STATE OF NORTH CAROLINA
DEPARTMENT OF TRANSPORTATION

July 18, 2003

Subject: Modification to Individual Permit; Wake County; Northern Wake Expressway;
State Project No. 8.U401711; TIP Nos. R-2000AA, R-2000AB, and R-2000AC;
Action ID No. 199920387 (Original Action ID No. 199601917) \$475.00 Debit
work order 8.2401701, WBS Element 34365.1.1

In compliance with Special Condition "m", we hereby request that the U.S. Army Corps of Engineers Section 404 Permit and the N.C. Division of Water Quality Section 401 Water Quality Certification be modified to reflect an increase of impacts to wetlands and surface waters from that described in our application dated March 29, 1996. The impacts are depicted on the attached revised permit drawings for Sections R-2000AA, R-2000AB, and R-2000AC.

PLAN VIEW
SITE 3

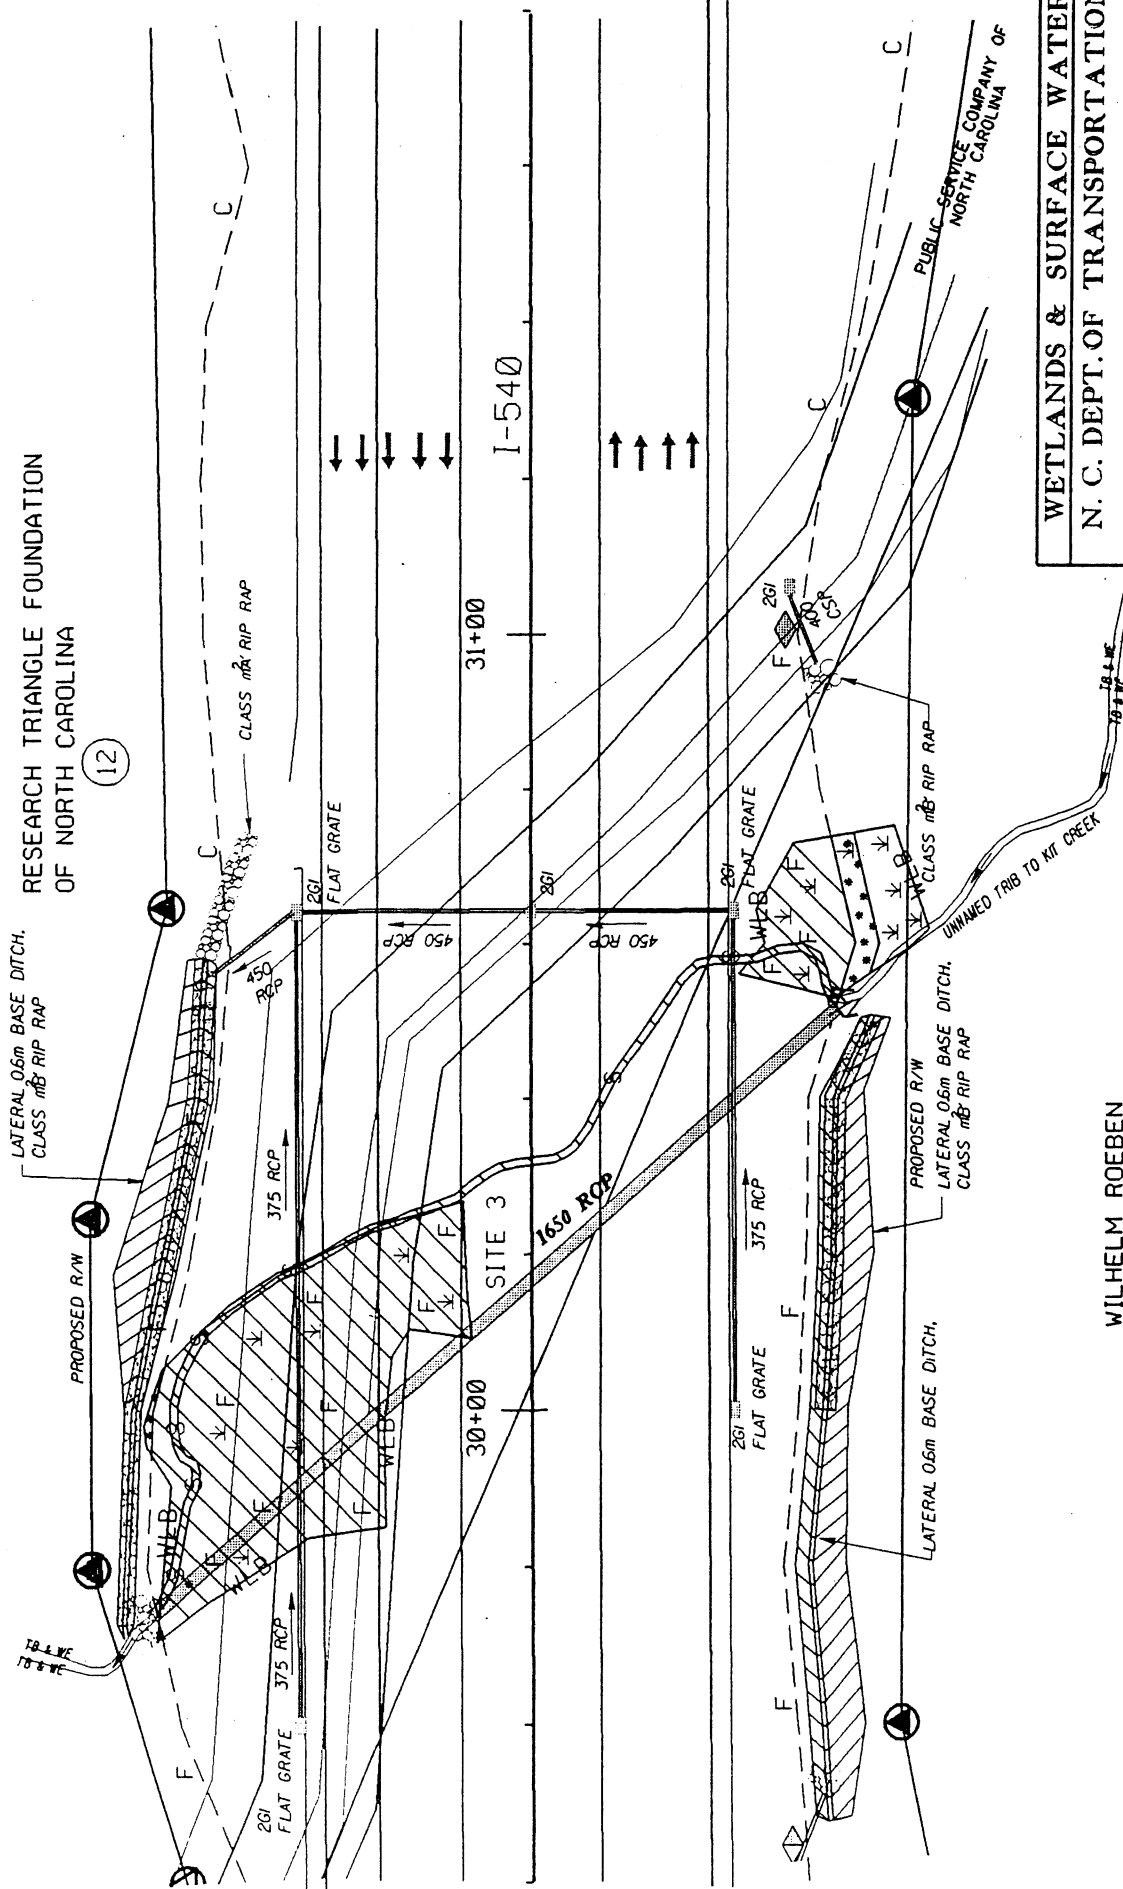
3. Site 3: Wetland boundary is now shown corrected and closed and ditch will be extended past the wetland. **No action required**
4. Site 4 RCBC: John stated that the culvert needs to be designed for bankfull. Sills are provided. Travis had a concern about rip rap show. Marshall stated that it would only be on the banks. Eric and John again asking about the sills, width and height, John commented that is seamed narrow, but was “Fine for now” **Action Taken: No rip rap will be place in the channel**

PLAN VIEW SITE 6

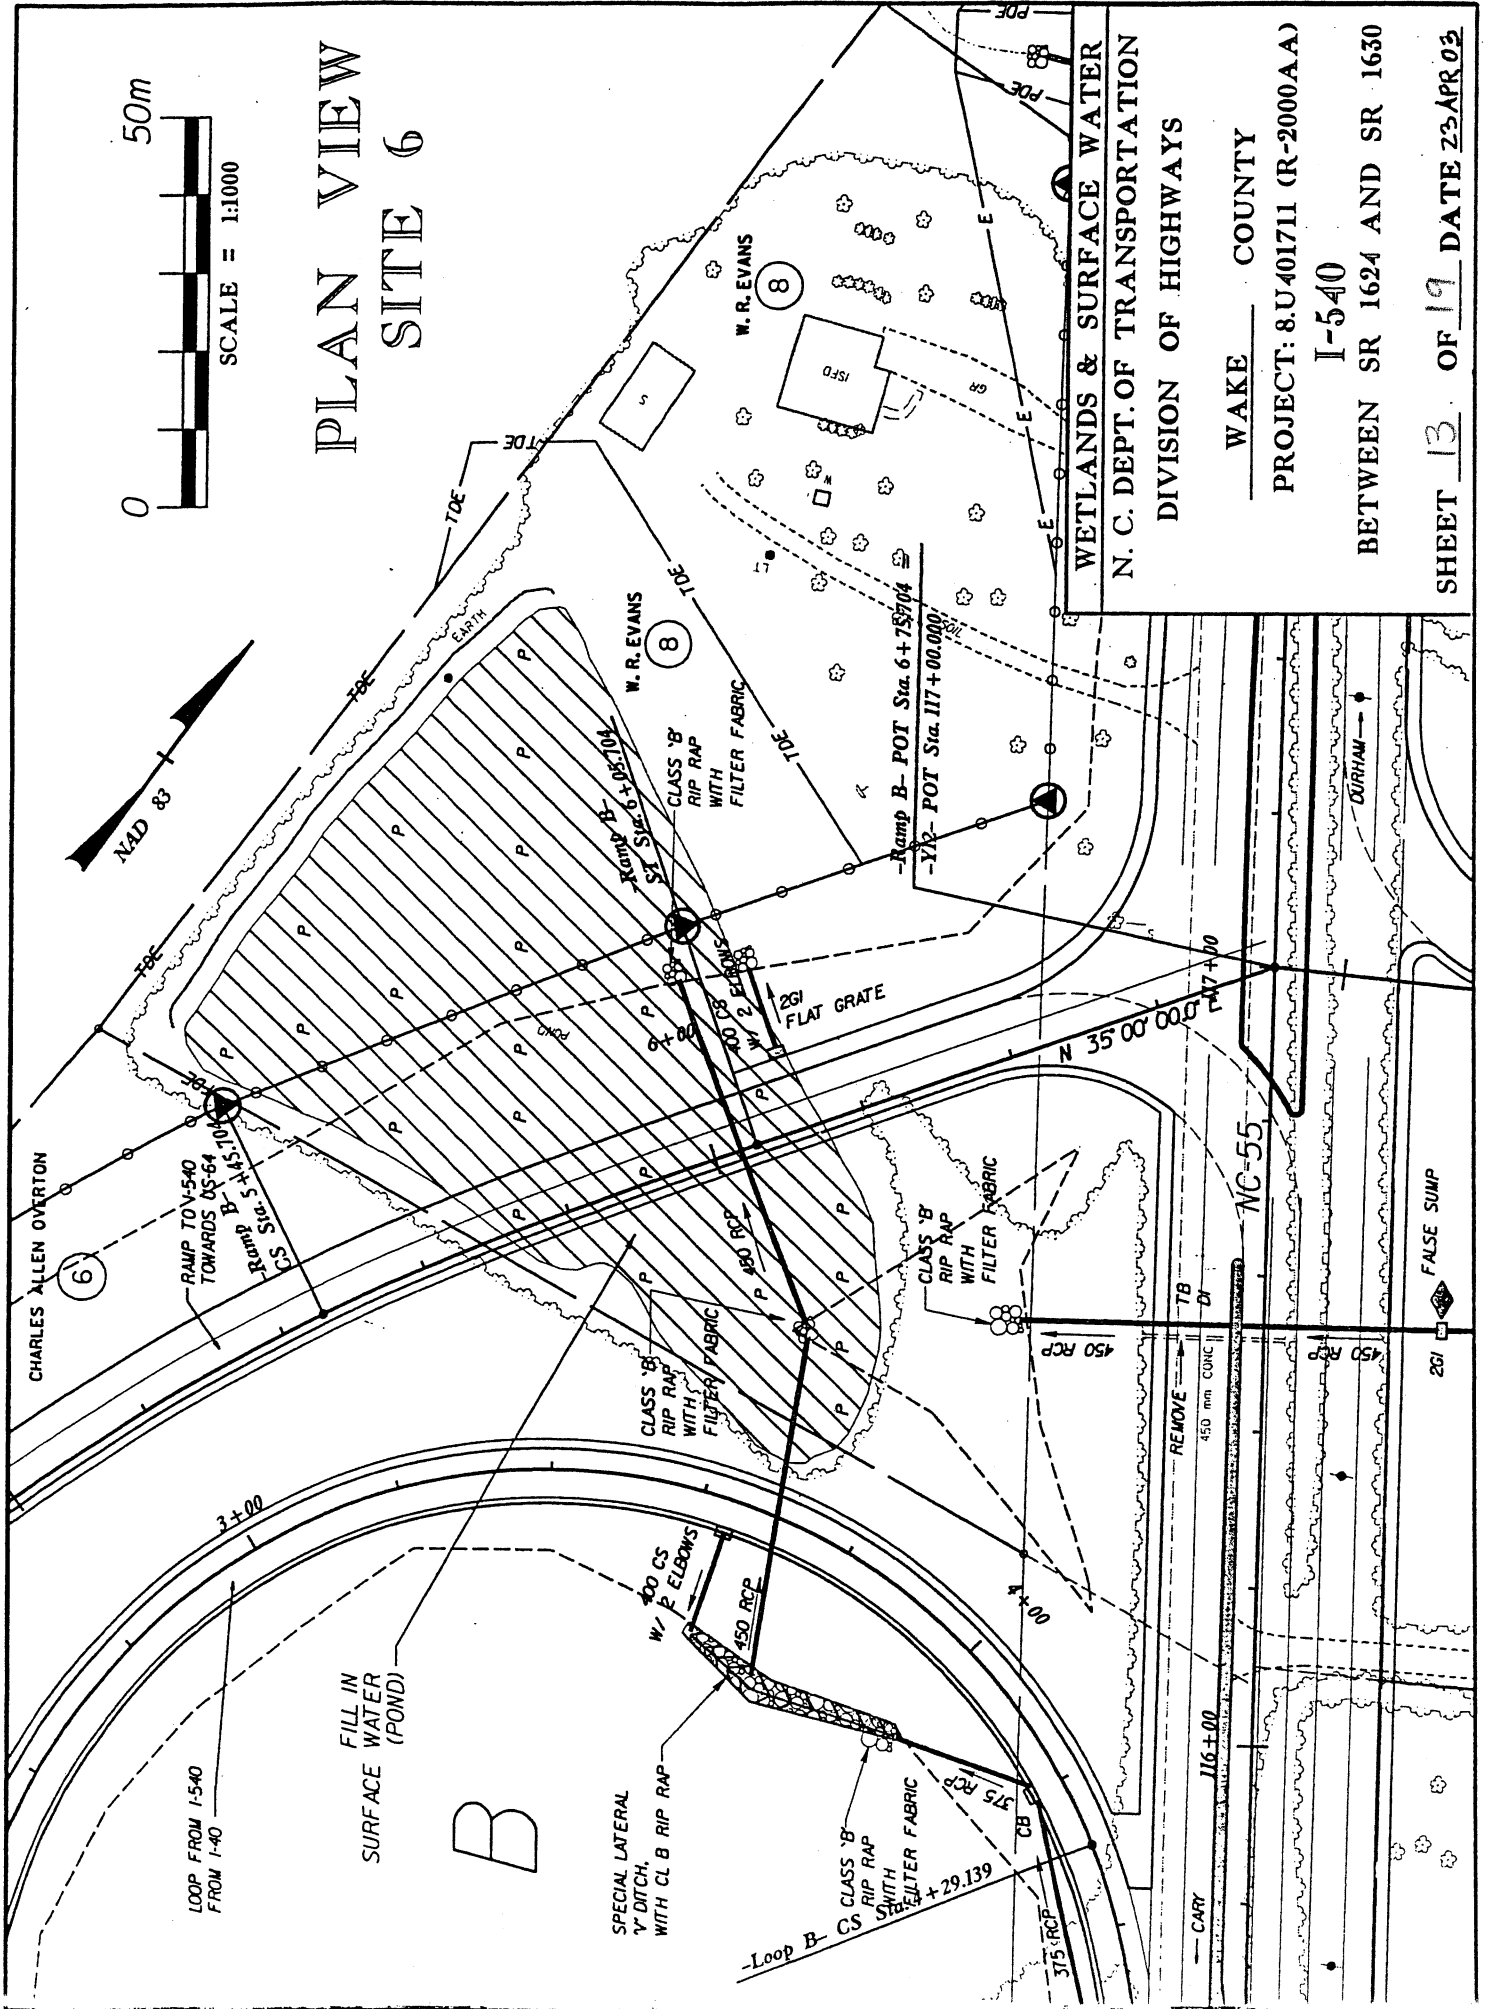
1. Site 1 and 6 Interchange at I-540 and NC 55: Eric and John had concerns about addressing the impacts associated with the full interchange and it needs to be address in its entirety. The Hydraulics Unit will provide half size plan sheets (Mailed 4/28/03) to Travis, John, and Eric for them to review. The half size plan will show (Original design) full interchange showing all the impacts associated with the interchange. **Action Taken: Half size plans were mailed 4/28/03 and an additional meeting was held on May 15, 2003 to address outstanding issues and concerns about the interchange.**

9) Site 10 (Buffer Site 2):

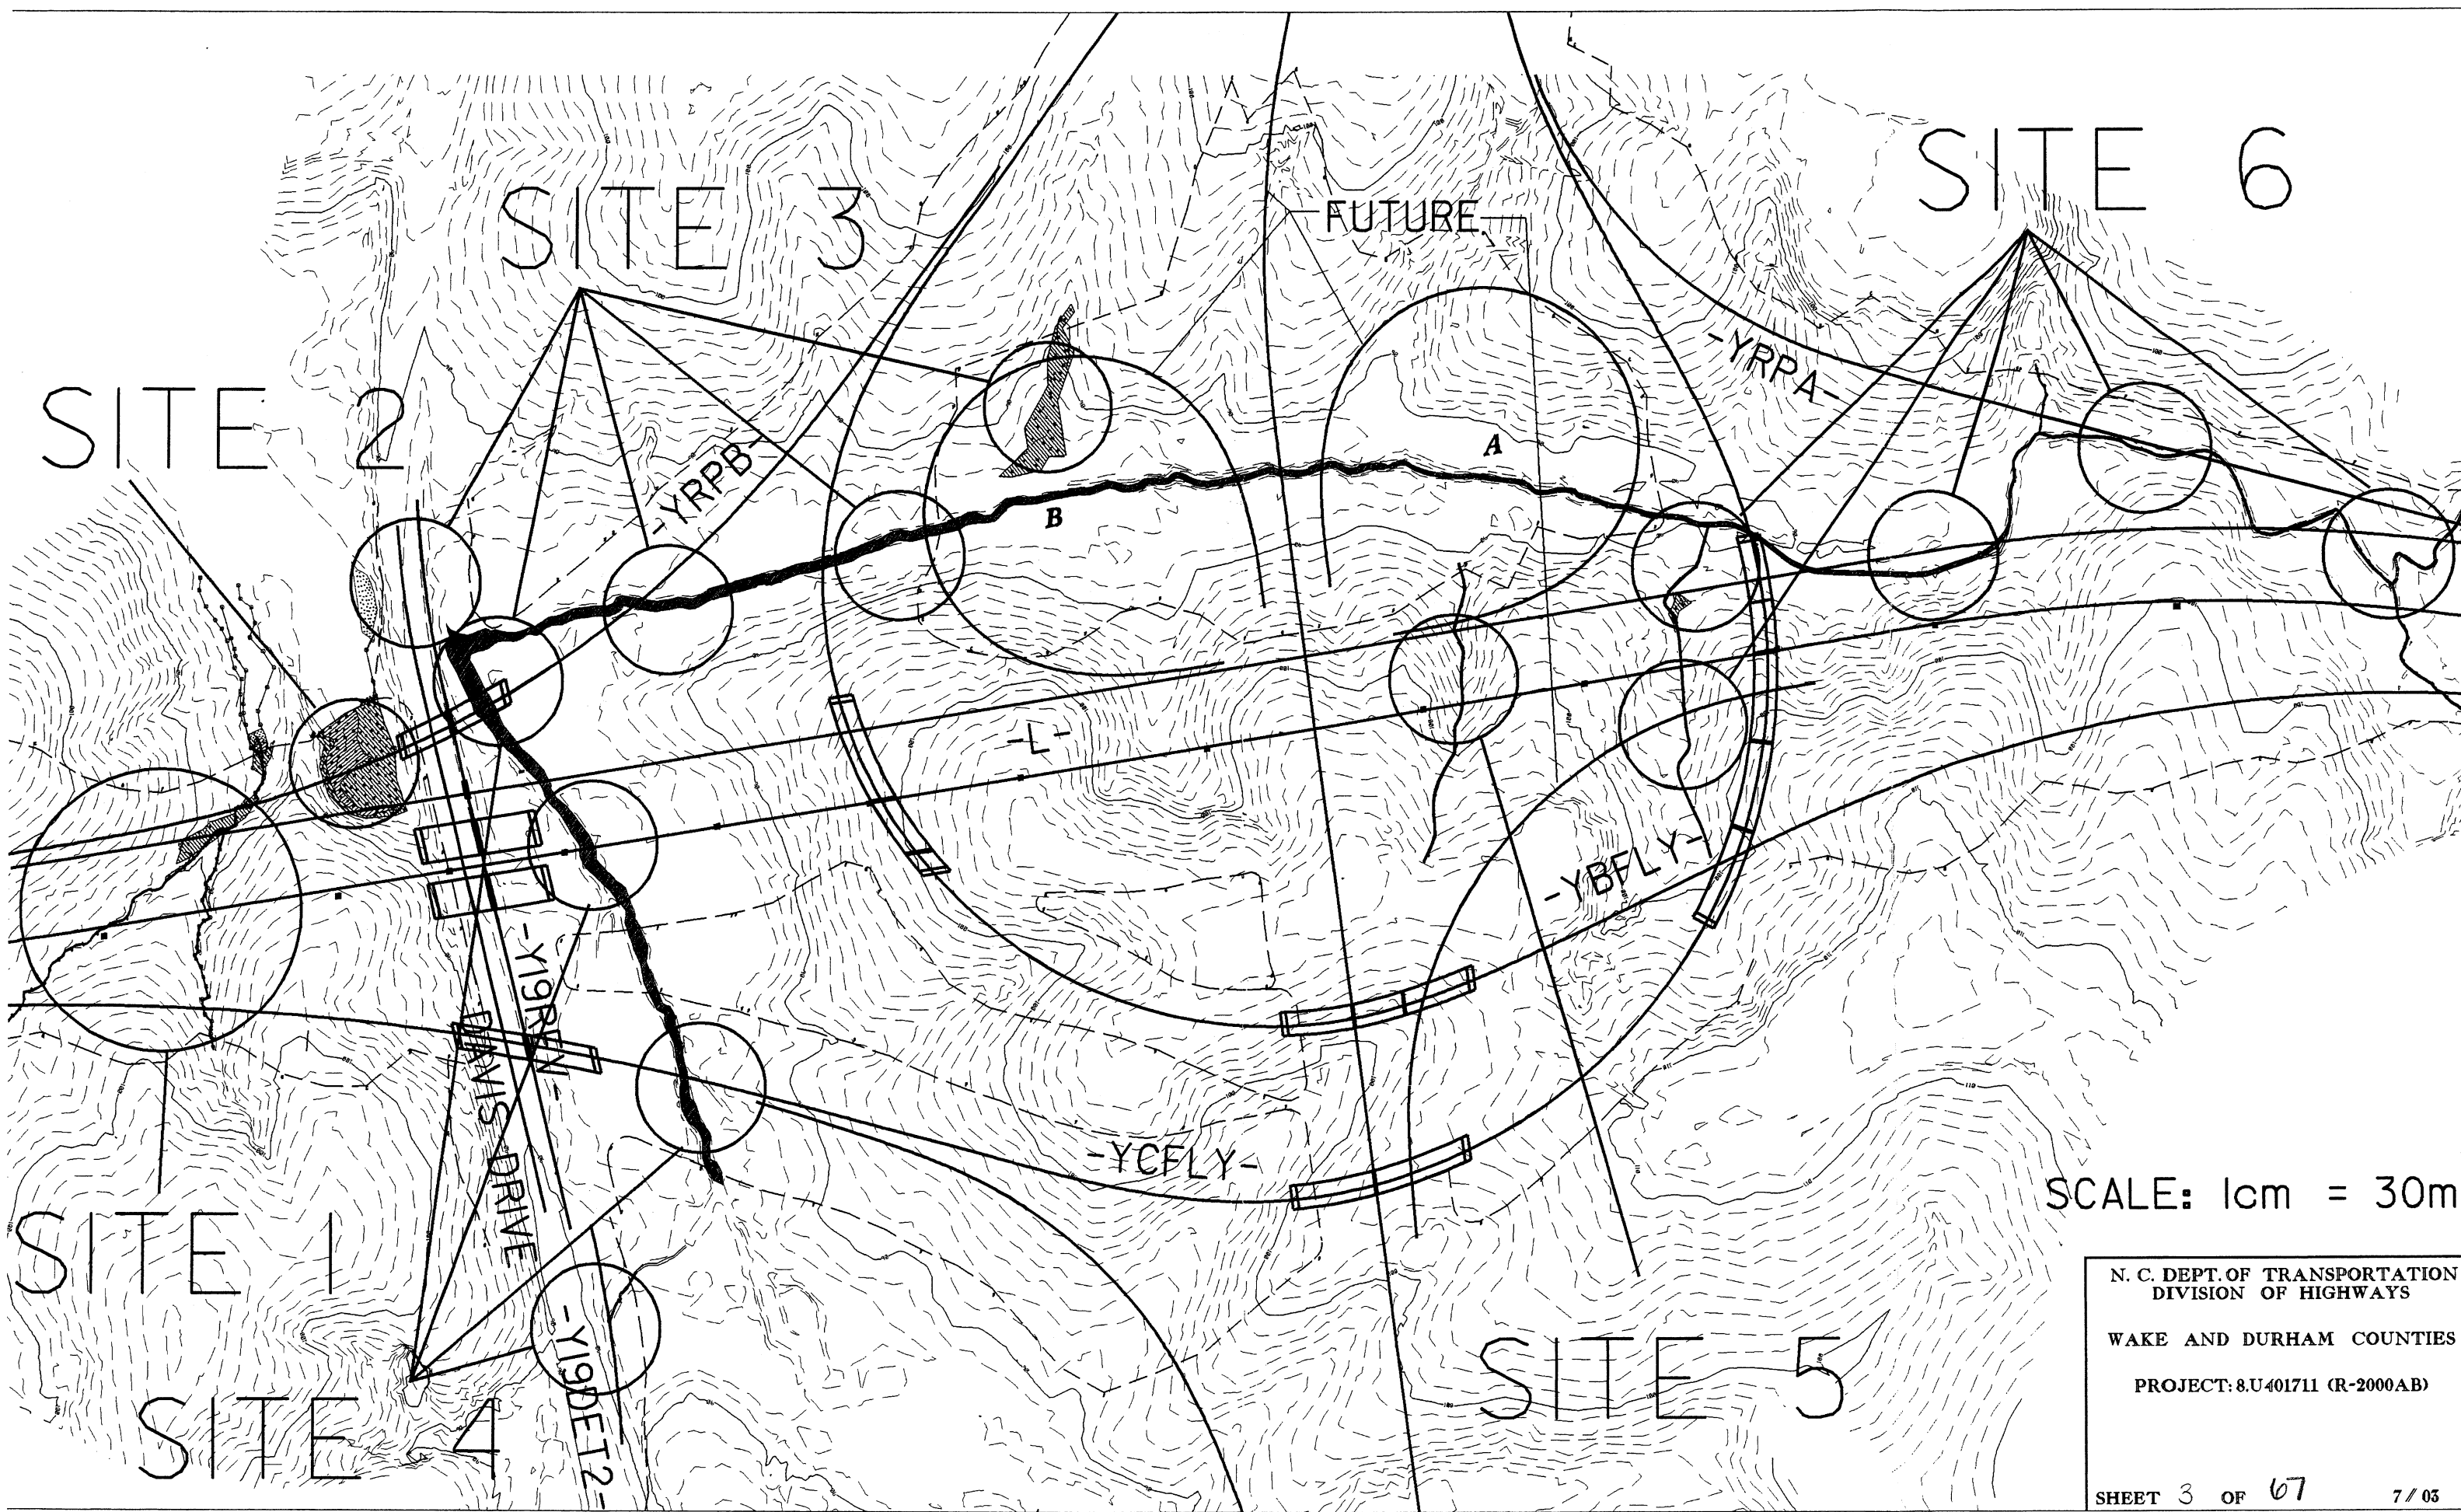
Alice Gordon stated that downstream of the pond was reevaluated and found not to be wetlands or a stream. Can eliminate as impacted on permitted. John Hennessy requested that a rock berm be used to diffuse flow at riser outlet.

Wetland eliminated. Class B outlet protection should be adequate since discharge outlets only when riser of upstream sediment basin is submerged.
